## ***Delegated Decisions by Deputy Leader of the Council***

### **OXFORD, KENNINGTON ROUNDABOUT AND HINKSEY HILL INTERCHANGE IMPROVEMENTS**

## Kennington roundabout proposals: May 2012 - summary of issues raised at consultation

## Hinksey Hill interchange proposals: May 2012 - summary of issues raised at consultation

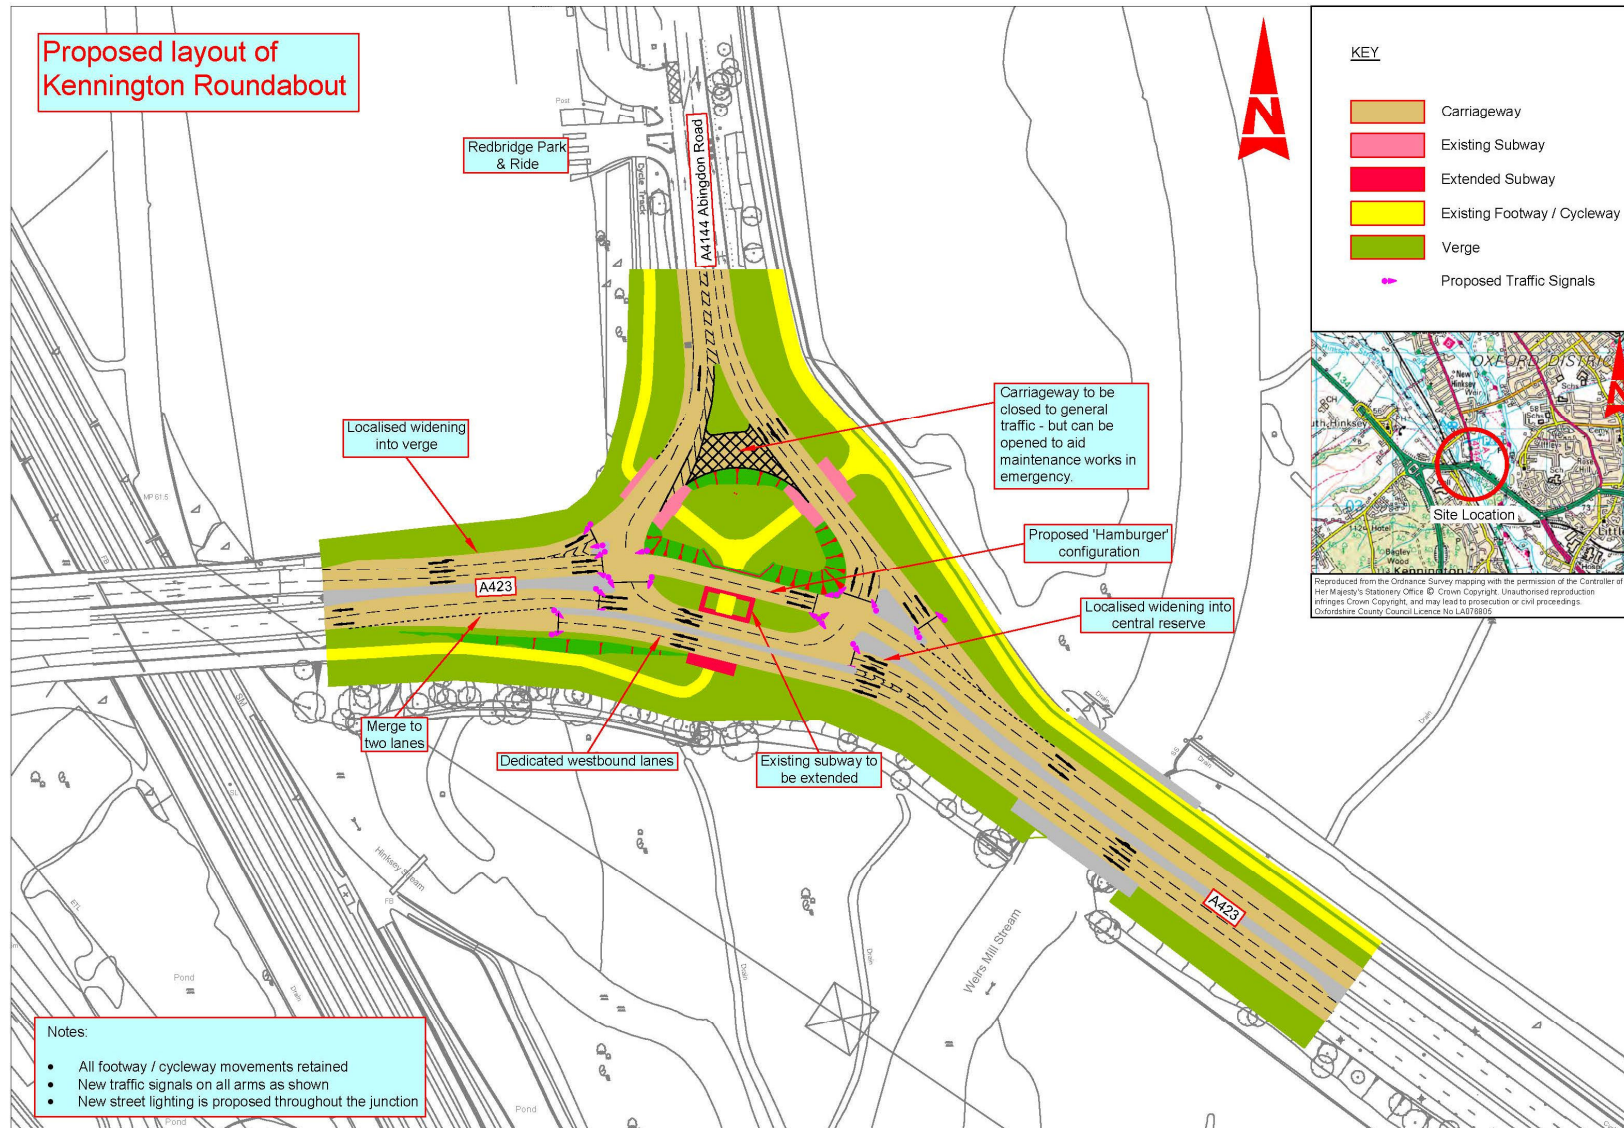
Issue	Detailed comments	County council response
Layout / merge	Traffic merging on the A423 westbound from the roundabout looks difficult. Merge distance looks quite short and might cause delays to westbound traffic and may present shunts /safety problems even with signals.	The extra lanes allow traffic to flow better and are not considered to cause safety issues. The layout will be subject to a safety audit and monitored after implementation.
	Two lanes of westbound traffic from Heyford Hill, travelling at great speed, merge with slower traffic from the roundabout circulatory (four lanes into two). It would be safer to have one westbound lane (three into two). Would it be better to have the faster Heyford Hill traffic in one lane? Three lanes to two lanes must be a better solution than four lanes to two?	
	Care is need to ensure westbound traffic coming from the Abingdon Road and traffic coming from the eastern arm of the roundabout from Heyford Hill going towards the Abingdon Road do not impede each other; these two streams of traffic have to share the inner two lanes on the south side of the roundabout and very careful phasing of the traffic lights will be needed to ensure that these two streams do not end up impeding one another. There appears to be less stacking space than the current two spaces. The existing situation is that there is generally offline space available to enable motorists to drive around the queuing vehicles. This not an option in the new layout because of the traffic island.	Careful phasing of traffic signals will help to ensure traffic flows are not impeded.

There is currently confusion when traffic trying to turn right into the Abingdon Road using the right hand turn lane on the approach to the roundabout then has to cross two lanes immediately on the roundabout in order to get in the inside lane at the next light, or to go in the middle lane with the through traffic which is more comfortable but doesn't help the flow of traffic (the right turn lane is often empty). Will the scheme make that choice clearer?	Appropriate markings and signage will be used to make the layout and destinations of each lane clear.
	Headington roundabout traffic going from the northern bypass heading to the A40 only has a single dedicated lane (left-hand lane). The adjoining lane should also be available, but is usually blocked by traffic waiting to continue around the roundabout but stopped at the traffic lights. As a lot of the traffic on the bypass seems to be heading for the A40 it is quite a problem. The bypass ought to be widened to allow an extra lane for a short distance for A40 traffic. Has this problem been addressed in the new plan for	The proposed Kennington scheme has been tested using computer modelling and the lanes allocated and signals phased to best accommodate the flows. This issue will be less of a problem at Kennington because the junction has fewer arms than the Headington roundabout.

Page 8	Kennington?	
	There should be sufficient lanes for the ring road movement on the entry arms to the roundabout so that this movement is not blocked by traffic waiting to continue around the roundabout.	
	Yellow box markings should be used to prevent exit blocking.	The need for keep clear markings / yellow boxes will be considered.
	A hamburger roundabout should not be required for a three-arm roundabout.	The proposed hamburger layout is considered to be a good solution and has been tested using computer modelling. It is correct to say that it will technically be a junction rather than a roundabout .
	Guide markings for the lanes are required on the westbound slip up to the point of lane merge.	Extension of the line markings will be considered.
	Ensure traffic can get out from Kennington slip road.	The situation will not be altered for traffic exiting from the Kennington slip road. Careful phasing of the traffic signals will be required to ensure that exit blocking does not occur.

An accident between the new traffic island and the roundabout would cause evening traffic en route to the A34 into a gridlock situation or force them into using Old Abingdon Road and the on-slip to the A423 W from Kennington Turn or SW to Heyford Hill and return.	Not every incident can be catered for. These are considered to be appropriate diversion routes in the event of exceptional incidents.
	Drivers not wishing to go straight through a hamburger roundabout find it very confusing, and there can be blockages causing delay. The placement and timing of traffic signals is particularly important.	This hamburger layout is simpler than others because the junction only has three arms. Clear signage and careful phasing of traffic signals will help to ensure traffic flows well.
Road markings	Right turn arrows are likely to cause confusion and are best avoided on the approach lanes to a roundabout. Where a right hand lane is dedicated to a specific destination, this should be associated with an ahead arrow until the vehicle is in the circulatory carriageway.	These will be reviewed as part of the detailed design.

The direction arrows on the exits from the roundabout towards Hinksey Hill and Heyford Hill roundabout are superfluous. If they are to remain the nearside arrow should be changed to a left turn one and both repeated twice more between there and the point the lanes at Heyford Hill split into three.	
	Is the off-side lane on the approach to the roundabout from Heyford Hill	Most drivers heading westbound from this point are likely to use

The division between the traffic using the bypass and that heading for the city centre should be delineated with a raised and kerbed traffic island and not just hatching painted on the road surface.	A traffic island is proposed to hold the signals and separate these flows.
Signage	Signage should be clear and accurate to ensure motorists are in the correct lane to make the movements they wish so that late lane changes are avoided on the approach to the roundabout.	Appropriate signage will be used to make the layout and destinations of each lane clear so that late lane changes and confusion are avoided.
	Ensure that signage at roundabouts is clear and accurate as to the lane situation at the entry to the roundabout; and not at the initial splitting of the lanes on the approach - or display a sign which makes it clear how the lanes split.	
	The present signage indicating the lane setup when travelling eastbound towards the Kennington roundabout from Hinksey Hill is misleading.

Early, clear signage, will be needed to warn drivers that the A34 lanes are on the left to avoid them going onto the roundabout.	
Speed limit	Is a change to the speed limit proposed?	No change in speed limit is proposed. A change was not considered necessary but the scheme will be monitored and speed limit adjusted if considered necessary.
Impact on Heyford Hill roundabout	Can Heyford Hill cope with the faster arrival of traffic as a result of these improvements?	The design of the three junctions on the southern approaches were developed together. Modelling has showed that the roundabouts will work well together.
Off-peak delays	Creating a place to hold vehicles in the middle suggests signal phasing will require two full stops instead of one. New lane looks expensive and seems to offer little advantage.	The proposed junction layout is considered to be a good solution and will make the junction operate better overall. The majority of users will experience an overall benefit, even off-peak. A small minority of journeys may be slightly longer through this junction at off-peak times. This is the case for all signalised roundabouts at off-peak times.

Traffic signals	Why are lights required on the southbound slip road when there aren't on other similar roundabouts? It would be better to remove the signal control for westbound traffic on the A423 and allow traffic from the Abingdon Road to merge normally even if this requires merging two lanes into one earlier. This exit could be free flow with a little widening work to the south embankment.	For safety reasons it is considered that these lights are needed. Widening is not possible due to limited budget.
	Roundabout should work in the event of signal failure. Signals should be part-time and used in peak times only.	In the event of signal failure the junction will operate as a priority junction which will require drivers to proceed with care. Traffic signals are required to balance the flows from different directions otherwise certain flows will dominate.
	Care needs to be taken with inter-visibility of traffic signals especially at the entry on to the roundabout from Heyford Hill.  The two sets of traffic signals at the merge points west of the roundabout will be controlling four lanes of traffic all en route to the same destination. Ensure high level of shielding of traffic signal lights from adjacent lanes.	Signal layout and orientation will be carefully designed.

Pedestrian crossing	Not all pedestrians will want to use the subway and so an at-grade route for pedestrians needs to be identified (perhaps across the A423 on the west side of the roundabout).	Whilst some pedestrians may prefer at-grade crossings the subway is a very good facility, creating minimal delay for both pedestrians and vehicles. In addition highway land and funding for the scheme is limited and alternative routes are already catered for by the subway or through Kennington.
Subway / routes for cyclists	Ensure that lighting in the tunnel is enhanced along the lengthened subway.	The subway will be lit.
	Ensure good directional signage, readable at the maximum available distance, above each portal.	This does not fall with the scope of this project as this would need to be part of a wider view of cycle route signage.
	Essential that there are proper alternatives for bikes.	The subway and the route via Kennington along the Old Abingdon Road which has recently been upgraded provide good alternatives for cyclists using this route. Due to limited budget, further improvements cannot be made as part of this scheme. However the council will continue to review cycle facilities and make improvements where possible.
